DUNDEE STOP REQUESTS

DUNDEE RD. AND DR. MARTIN LUTHER KING ST SW.

Exhibit A

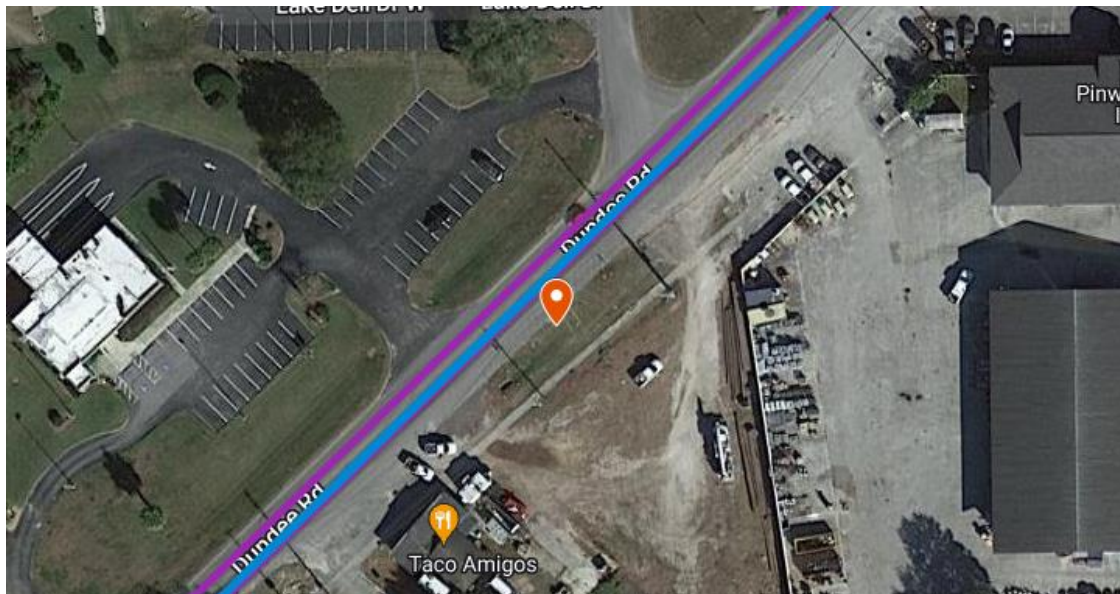
Staff does not recommend a stop at this intersection due to a drainage ditch in the area (see Exhibit A) that would be a hindrance to ADA compliance. However, we do recommend a stop placement roughly 500 feet east of this location (see Exhibit B). This secondary location already has infrastructure for a sign as well as available space for further development, such as a boarding and alighting pad. Additionally, ADA compliance is not a concern here. Please see Appendices 1-4 for additional photos.
